1 **Q. Re: Tab 4.4 - Rebuild Distribution Lines Update – Stainless Steel Pole Mounted**
2 **Transformer Hanging Brackets**

3
4 **Newfoundland Power outlines it had discussions with the manufacturer of the**
5 **hanging brackets. Please provide all written correspondence between**
6 **Newfoundland Power and the manufacturer regarding the hanging brackets.**

**Email Correspondence
Between
Newfoundland Power and ABB**

FIGURE 2
 Brackets Technical Drawing

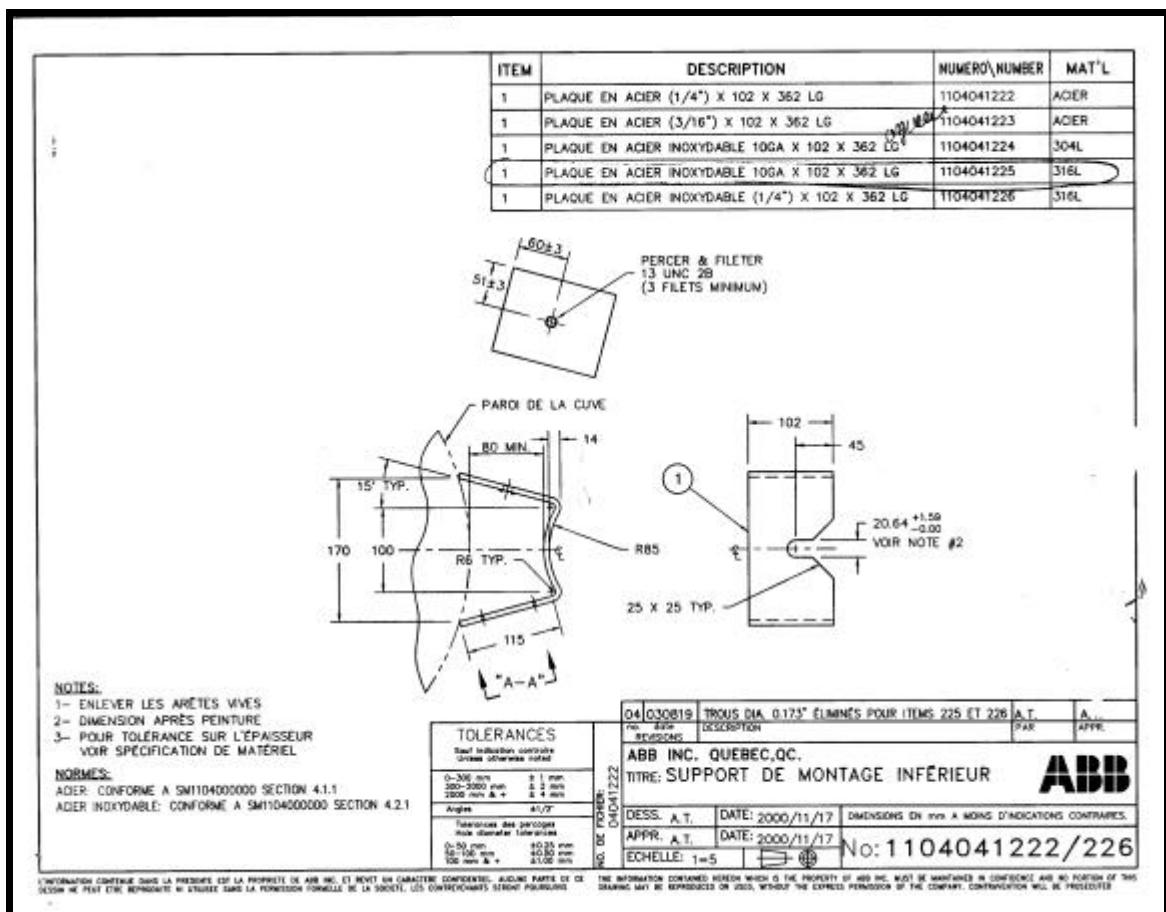
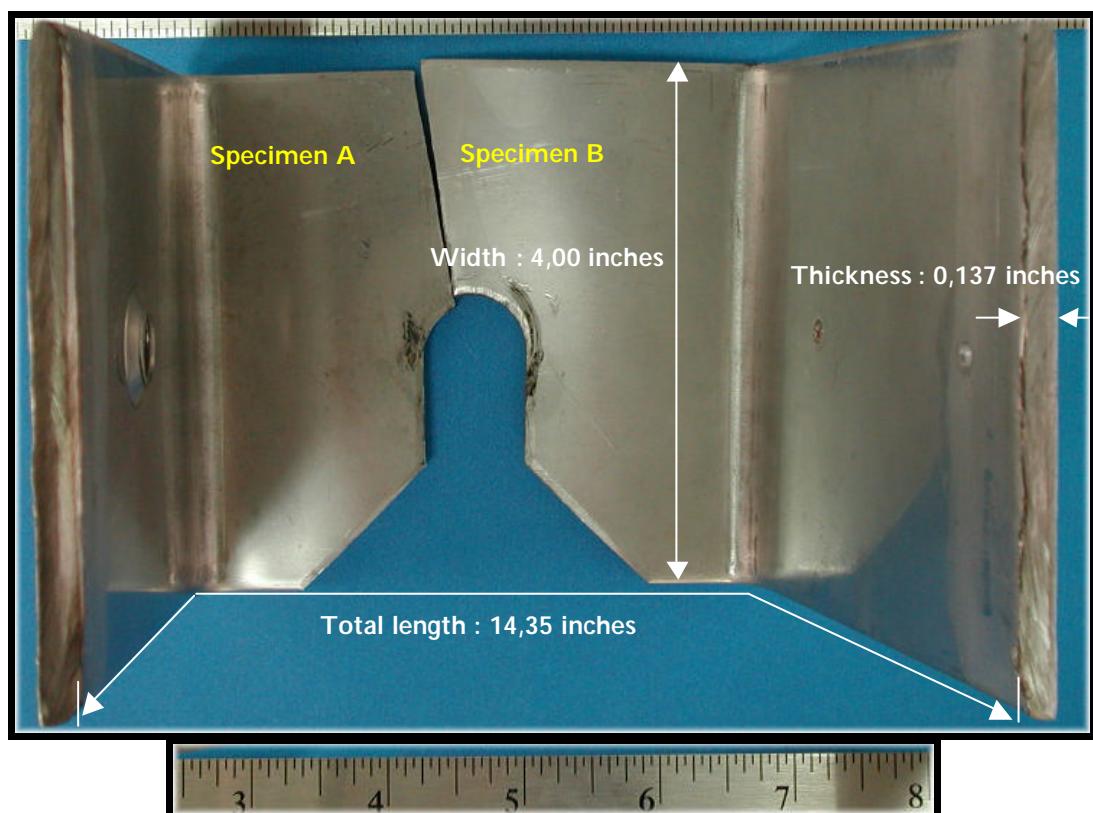
The mounting bracket must be made according to drawing N°1104041222/226 specifications (Figure 2). It can be noticed from the item description that five different parts can be made by changing the material and the sheet thickness.

Those dimensions are in accordance with the drawing. It was however not possible to measure precisely the other specified dimensions since X-PER-X does not have the appropriate tools and set up.

FIGURE 3
Schematic Representation of the Stress Distribution

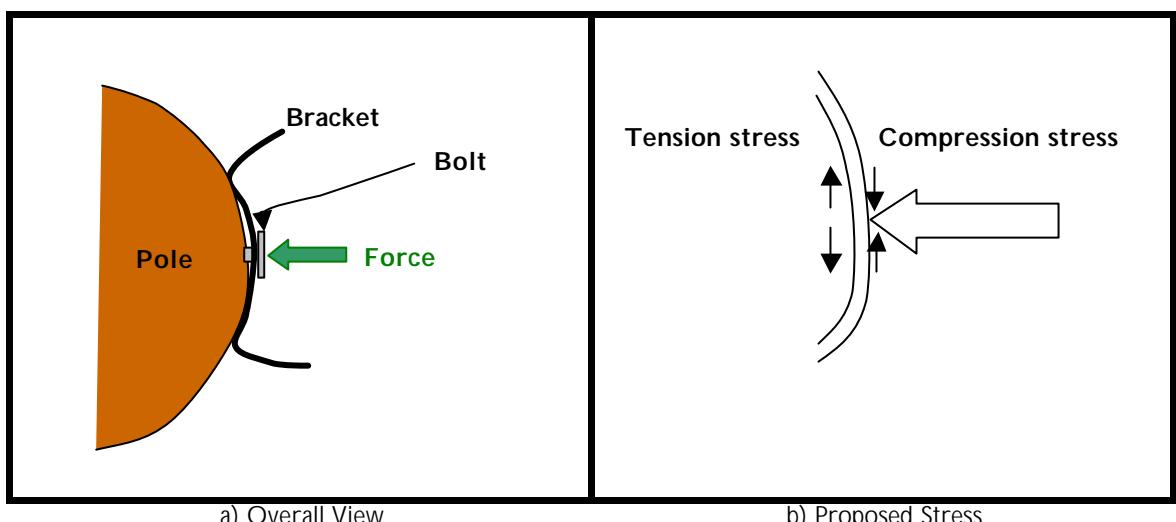
a uniform print on the plate. This is an indication that the stress transferred to the plate was not homogeneous. Moreover, applying a high torque could have induced localized tension stress on the plate pole surface. Especially if the bracket did not exactly fits the pole shape (Figure 3).

This tension stress was localized in the bolt area at the plate pole surface. This could explain the premature failure initiation. It is consistent with the fact that region II is larger near the bolt hole than in the upper region (Pictures n° 5).

PICTURES N° 8
Microscopic Observation of the Bolt Area, Specimen B

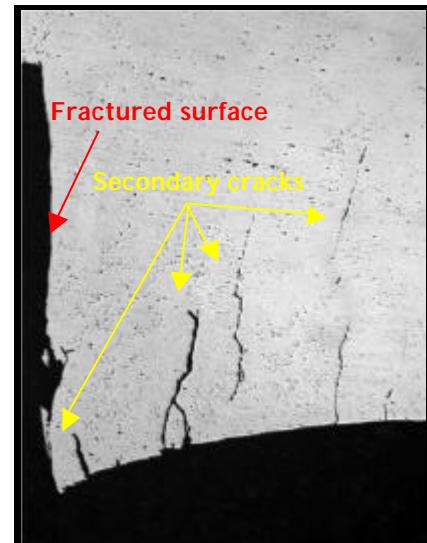
The scratches and deformation observed on the plate transformer side probably accelerated the second step of failure. Any surface discontinuity acts as a stress raiser from which fatigue cracks are more susceptible to initiate. To verify this hypothesis, a section was cut perpendicular to the ruptured surface and observed by optical microscopy (Pictures n° 7b and n° 8).

Many secondary cracks were observed. This is an indication that failure initiated in the bolting region. This area was highly stressed. Metallographic observations of the sample were also performed to reveal any sign of material defects (Pictures n° 9).

PICTURE N°10 (120X)
Microstructure in the Plate Plane Near the Bolt Hole

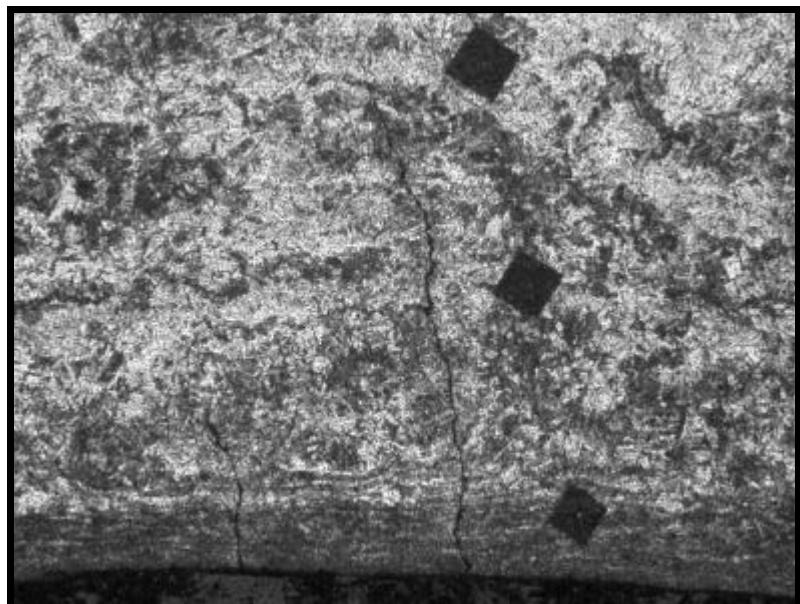
The samples were polished and etched with marble. Their microstructure is typical of a type 316L stainless steel. It is composed of one phase only, austenite. When looking at a plan parallel to the plate surface, picture n° 9a, the grain are equiaxed and the structure is homogeneous. However, the microstructure of the transversal section bears sign of sheet forming. Its banded structure is typical of laminated products. One particularity could also be confirmed by metallographic examination. The material around the bolt hole was significantly deformed (Picture n° 10).

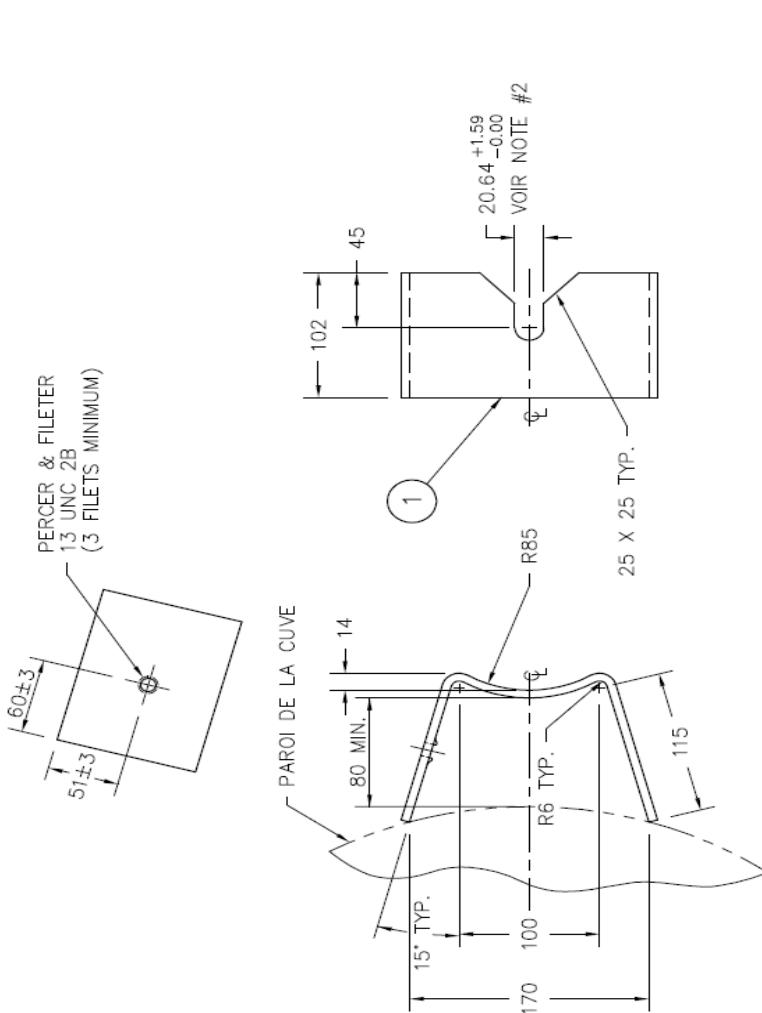
ABB, based on NP comments started to supply a thicker hanger bracket on transformers up to 50 Kva, no amendment has been added in Newfoundland Power specification. ABB has been supplying thicker material at the beginning of new contract in January 2007, increasing the thickness of brackets from 10 GA (0.140") to 3/16" (0.1875").

TOP BRACKET ASSEMBLY PLAN VIEW

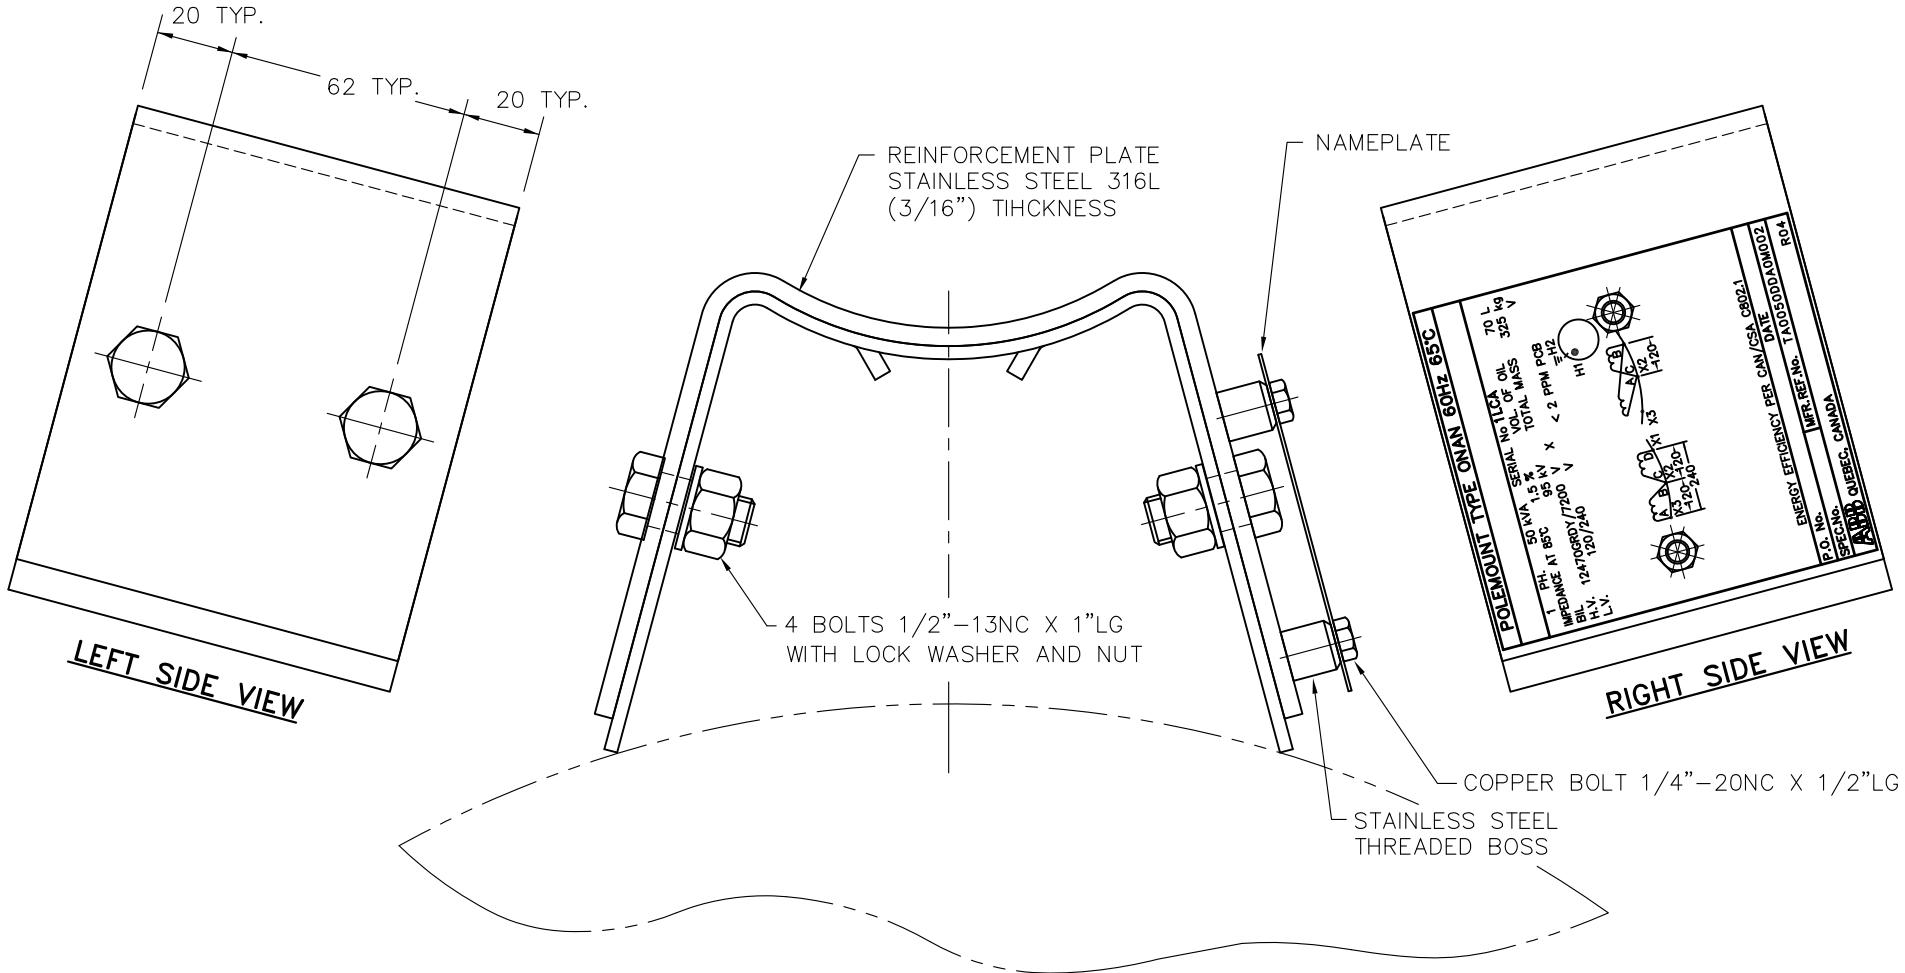
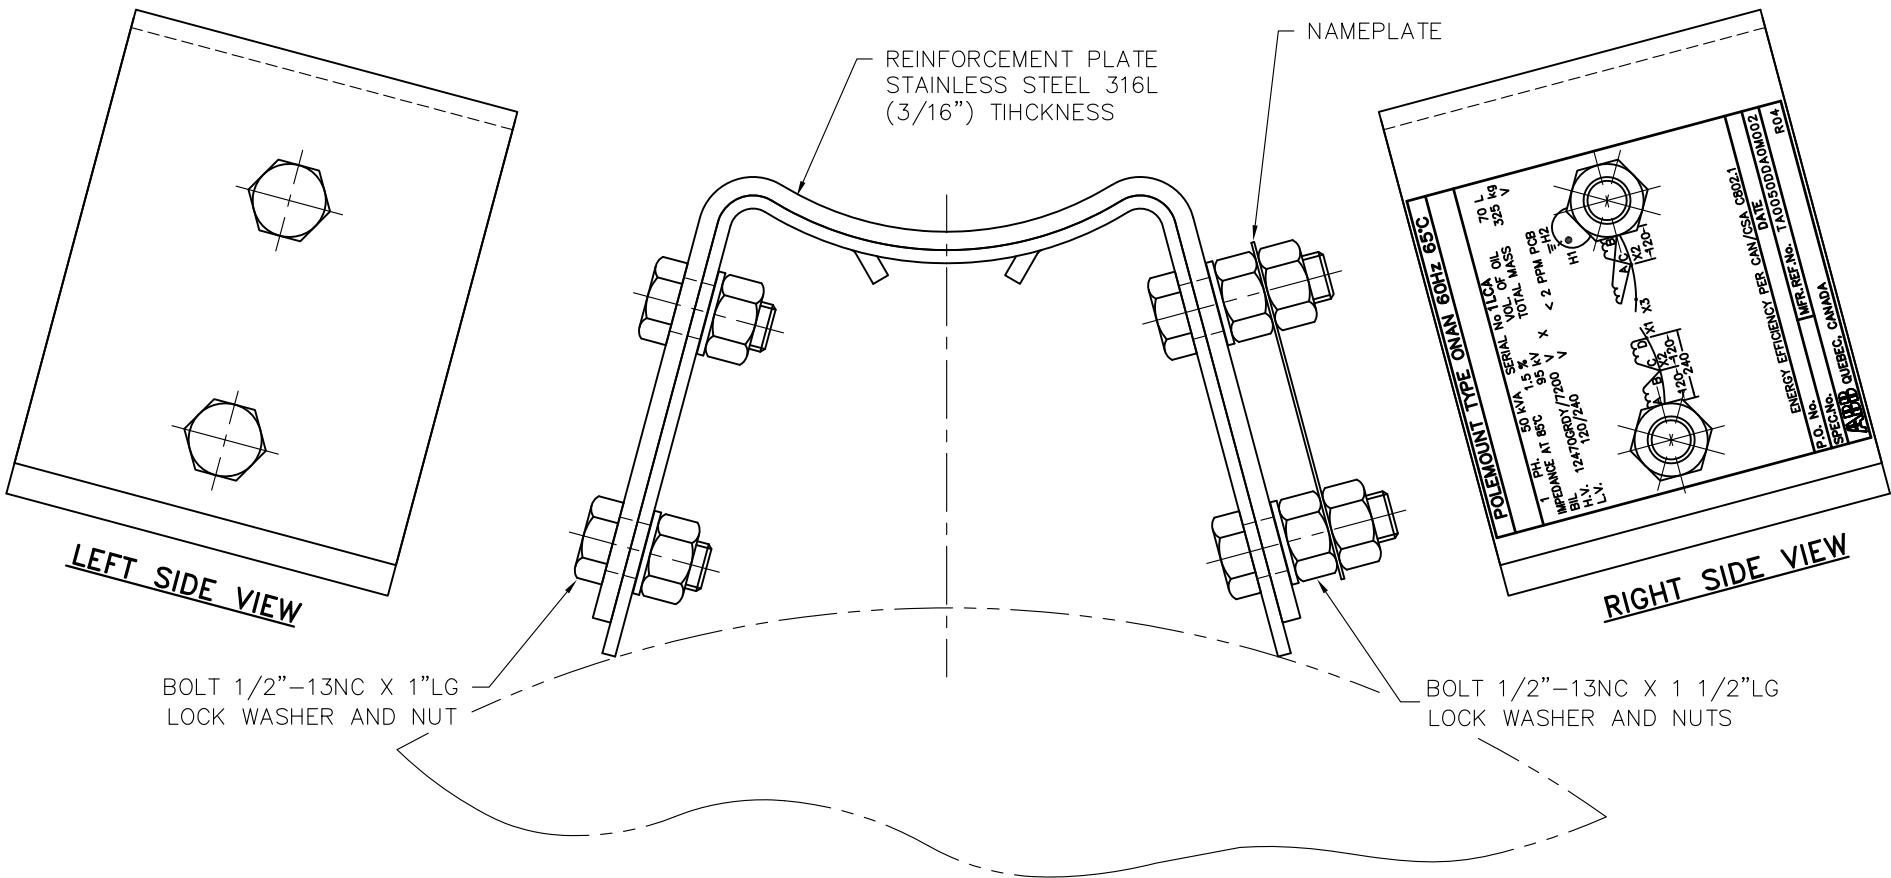
I have taken your drawing of the top reinforcing bracket assembly and modified it for discussion purposes. The modified drawing of the top bracket is attached. Would it be possible to modify the design of the reinforcing bracket, as shown to make it easier to install in the pole? The dimensions of the reinforcing bracket could be different than shown. Our suggestion is to enable the bracket to be bolted to the existing hanger bracket without drilling or punching the existing bracket.

I like your idea. It's a good idea but I need to verify with our supplier if this style of bracket is feasible. I will verify and I will let you know as soon as possible.
